Memorandum

TO: Michael McLaughlin, City Manager *mpm*
FROM: Jessica Bellah, Community Planner
VIA: Celia Craze, Director, Planning and Community Development
DATE: February 4, 2016
RE: Staff Review Greenbelt Station South Core Phase 3, DSP-13045

Figure 1

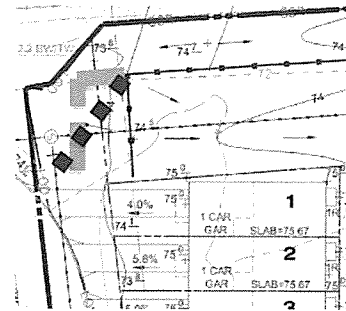
- 5) The applicant shall either extend the entirety of the noise barrier wall further south or turn the southern end section on the diagonal with the end wall terminating closer to the driveway entrance of Lot 1. See Figure 1.
